SERVICE BULLETIN

MODIFICATION – MECHANICAL RELEASE SYSTEM, CARGO HOOK KIT INSTALLATION, PN 369H90065

All Models 369HS and 369HE Helicopters With Cargo Kit, PN 369H90065, 369H90065-501 or 369H90065-511 Installed

Figure 1. Removal - Existing Collective Grip Release Mechanism

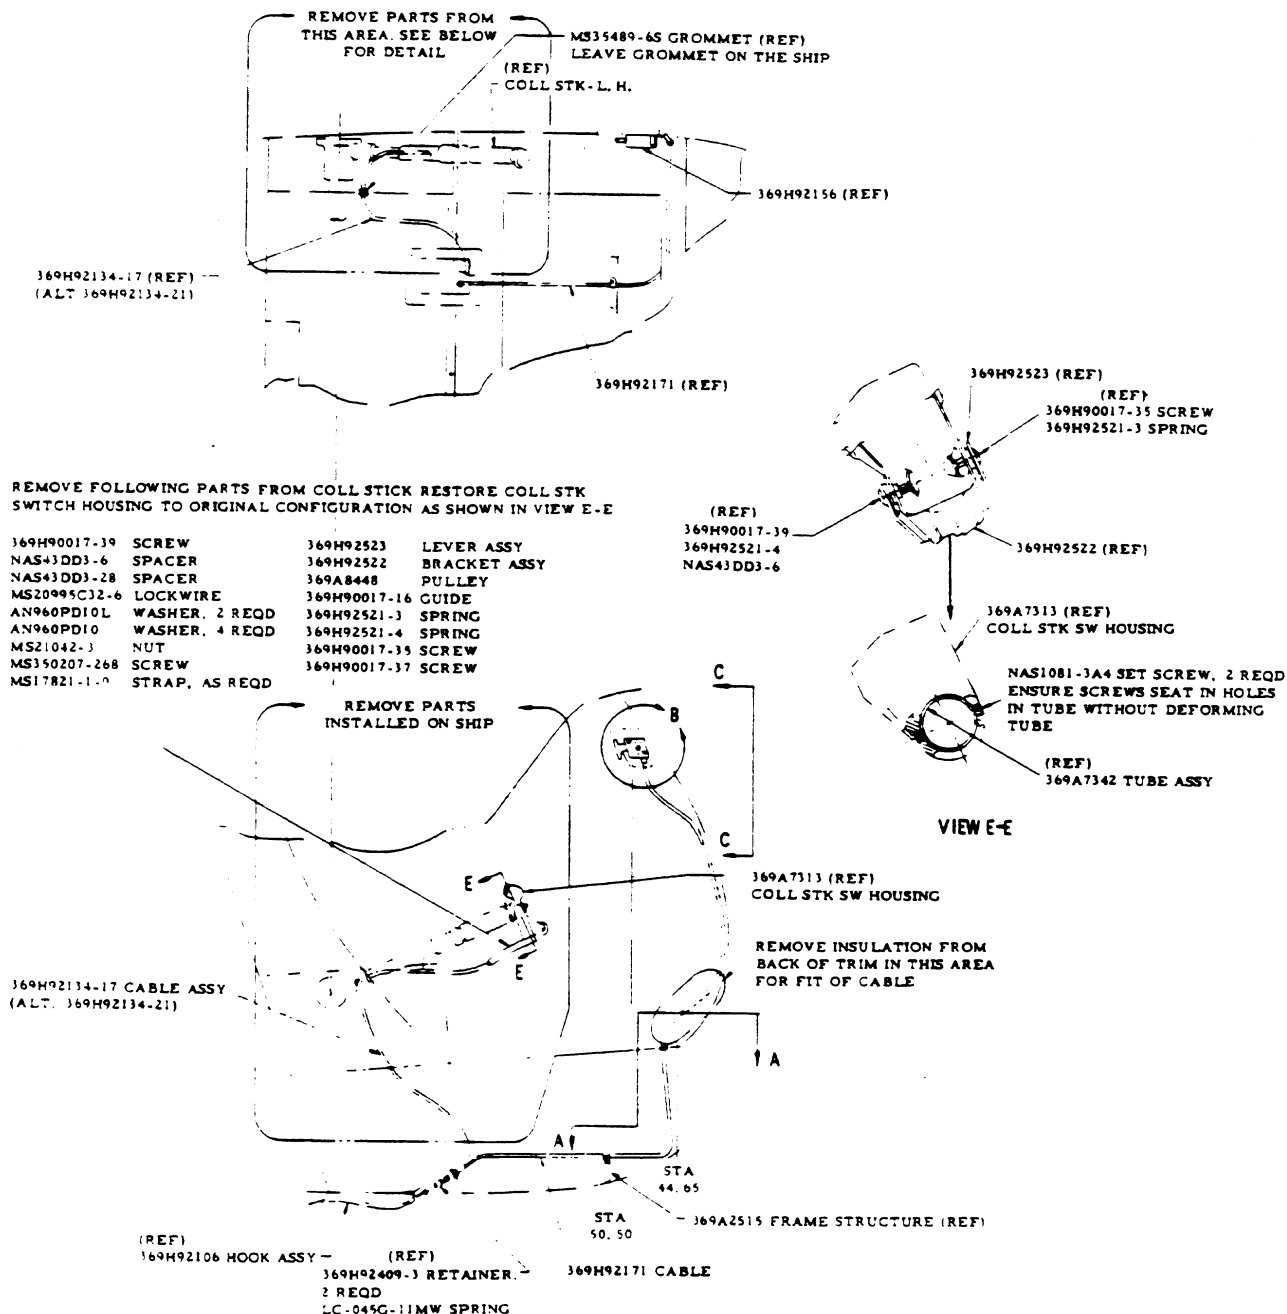
NOTE: To facilitate modification, replace existing two lever pivot screws one at a time with NAS1081-3A4 set-screws. Ensure that set screws are seated in holes in collective tube without deforming the tube. Also, remove existing 369H90017-37 balance screw from collective switch housing (see Figure 1).

NOTE: As required, remove channel from trim panel and enlarge slot in trim panel to ensure easy lie of cable. Also, remove sound insulation from back of trim panel at area shown for fit of cable. (See Figure 1.)

Figure 2. Installation - T-Handle Release Mechanism

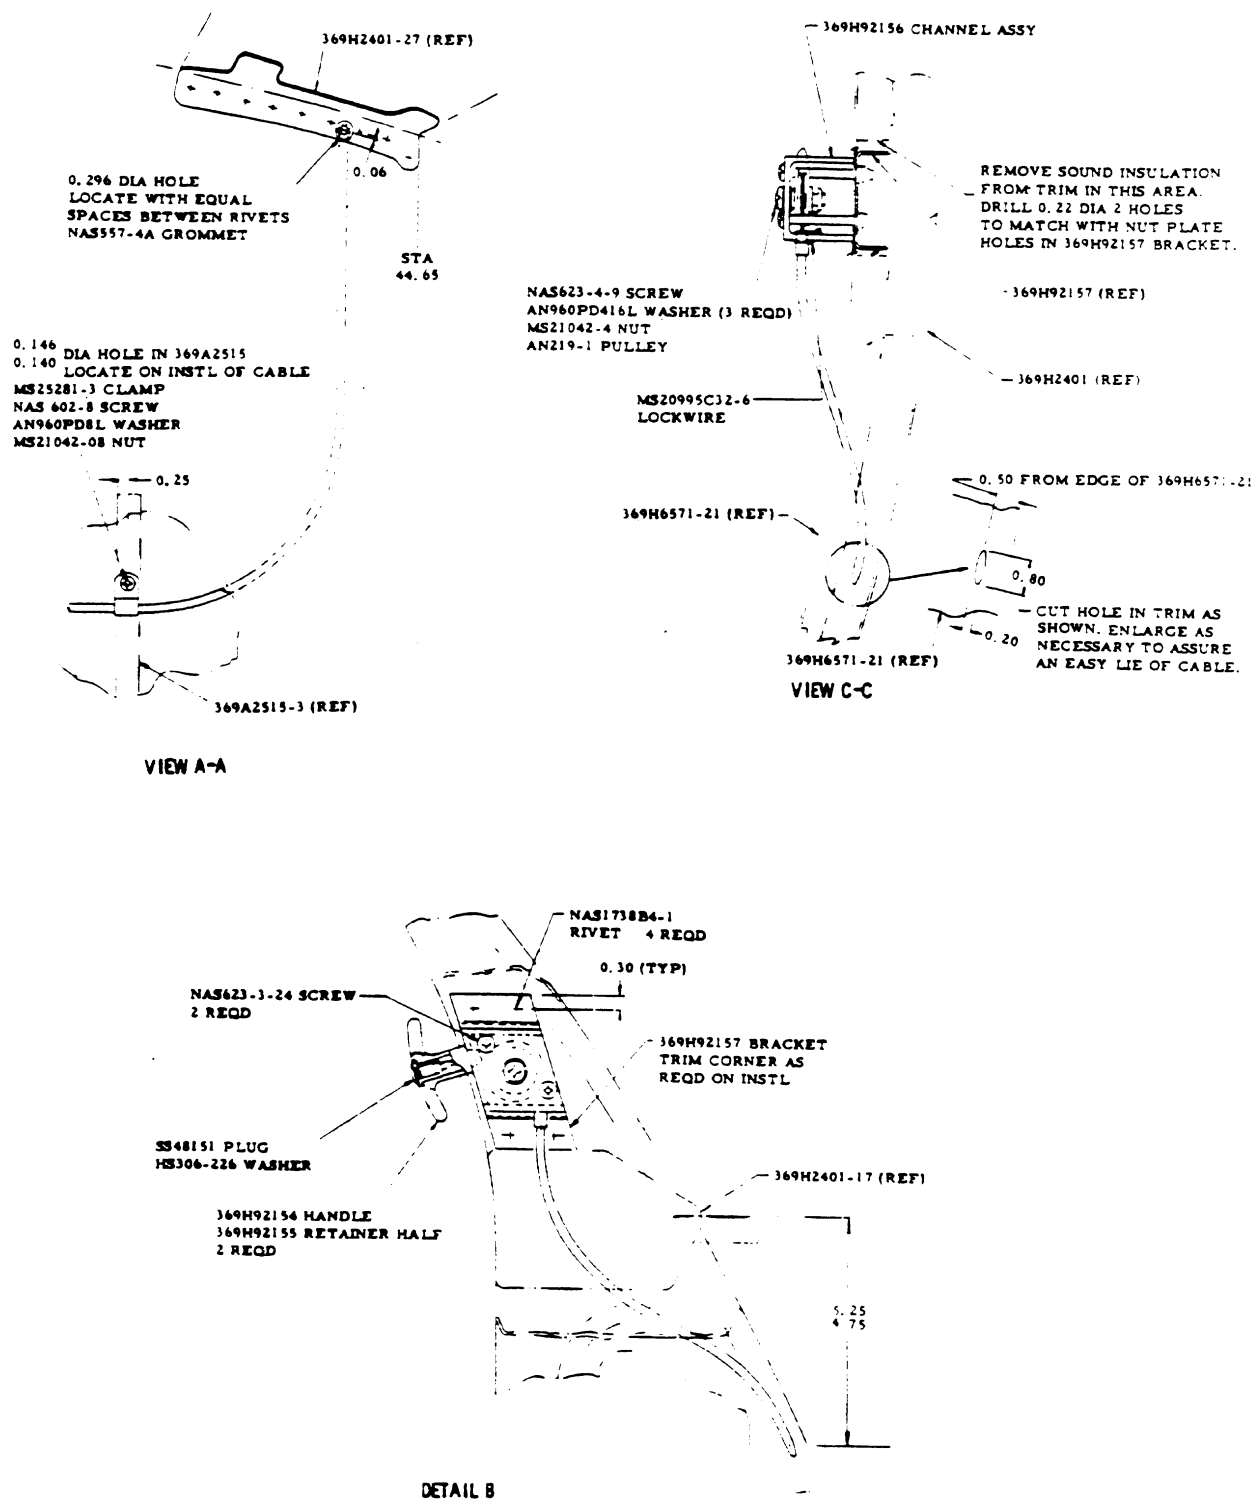
- Remove 369H6571-21 crew compartment left-hand forward door frame trim panel. (Refer to Section 4 of 500S/E - HMI Configuration Supplement.)
- Position 369H92157 bracket as shown on forward section of door frame structure above 369H2401-17 doubler. Mark and drill four 0.125 inch diameter holes in door frame structure to match bracket. (See Figure 2, Detail B.) Trim bracket corner, as required, on installation.

- c. Install bracket to door frame structure with four NAS1738B4-1 rivets; install rivets with zinc chromate primer.
- d. Drill 0.296 inch diameter hole at dimension shown in 369H4201-27 door frame angle (at Station 44.65); install NAS557-4A grommet (see View A-A).

- e. Position door frame trim panel in place; drill two 0.220 inch diameter holes in trim panel to match nutplates on 369H92157 bracket (see View C-C). Remove sound insulation from back of trim panel to accommodate bracket.

- k. Reinstall left-hand forward door frame trim panel.
- l. Drill 0.140/0.146 inch diameter hole in 369A2515-3 electronics compartment frame at dimension shown at Station 50.50; coat hole edge with zinc chromate primer. (See Figure 2, View A-A.)
- m. Secure cable with clamp on frame at Station 50.50, Using screw, washer and nut.
